PARTS & SERVICE NEWS

REF NO.	AA03055C
DATE	Dec. 4, 2003

SUBJECT: TRANSMISSION SHIFT TIME LAG TOO LONG

APPLICATION: WA380-5L Wheel Loader S/N A52001 thru A52063

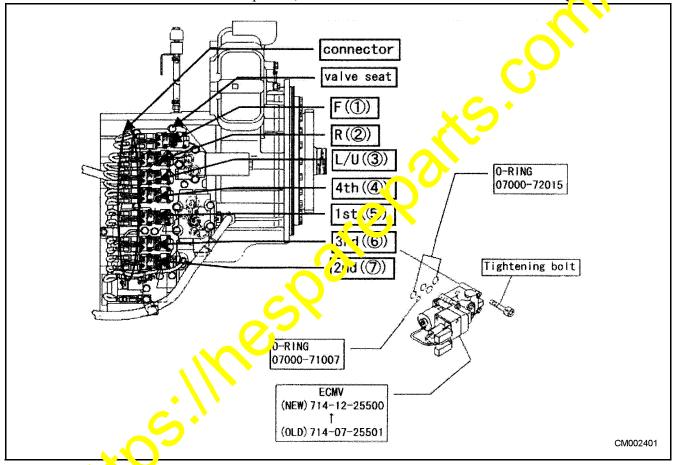
- ii. Disconnect all ECMVs connectors (12 connectors for standard transmission, and 14 connectors for "lock-up" transmission).
- iv. Respecting the order, begin to remove the ECMVs for Rear clutch first, and Forward clutch next.
 - *** Make sure to put a masking tape on the valve seat once R clutch is removed. ***
- v. Respecting the order, install the modified ECMVs in using new O-ring provided, starting by the F clutch and finishing by R clutch.

Installation torque: $7.8 \sim 9.8 \text{ Nm} (5.75 \sim 7.22 \text{ lbf ft})$

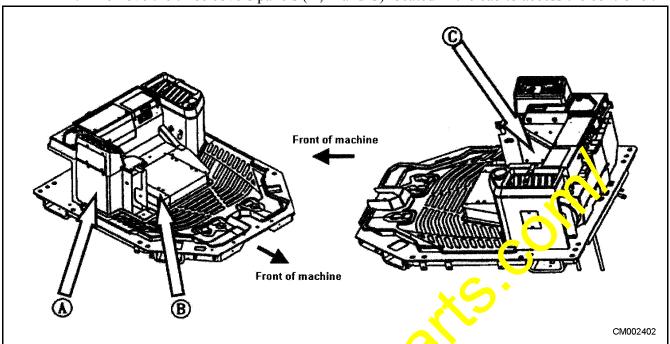
i. Remove the three covers panels (A, B and C) located in the cab to access the controller.

ii. With cover panel "A" remove, you can searc for the transmission controller (shown in graphic, right, below). Refer to graphic on ag. 4 to confirm the old controller part number.

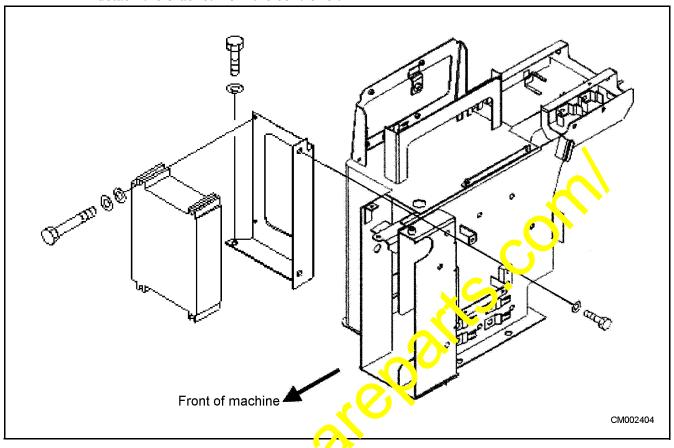
iii When the transmission controller is identified, remove the connector attached to it.

iv. Remove the controller with the attached bracket from the console box Then you can detach the bracket from the controller.

- v. Using the updated controller provided (P/N 7823-32-2008), reverse the previous steps to reinstall.
- vi. Using the monitor pant (m) he cab, execute an initial learning of the transmission referring the attached copy of the shop manual ➤ "Structure and Function" ➤ "Machine Monitor" ➤ "Setting of Machine Monitor" ➤ "Setting Necessary for Option Mounting" (WA380 page 10-216 to 10.251, WA450/480 page 10-248 to 10-250).
- 4. Re-mersuring transmission shift time-lag.
 Using the instructions describe under the step 1B of this Part & Service News, measure again the lag for each clutch, and take note of the new results.
